GROUP BOD	MODEL 2016MY Cadenza (VG)
	NUMBER 171	DATE December 2017
TECHNICAL SERVICE BULLETIN		
SUBJECT: CLUSTER FASCIA PANEL REPLACEMENT

SUBJECT: CLUSTER FASCIA PANEL REPLACEMENT

Replacement Procedure:

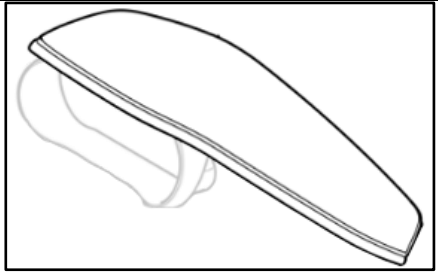
This bulletin provides information regarding the replacement of the cluster fascia panel on some 2016MY Cadenza vehicles, produced from March 16, 2015 through January 1, 2016, which may exhibit wrinkles or deformation. Follow the procedure outlined in this bulletin to replace the cluster fascia panel with an improved part.

1. Replace the cluster fascia panel by referring to the “Body (Interior and Exterior) → Interior → Crash Pad → Repair procedures” chapter in the applicable Shop Manual on KGIS.
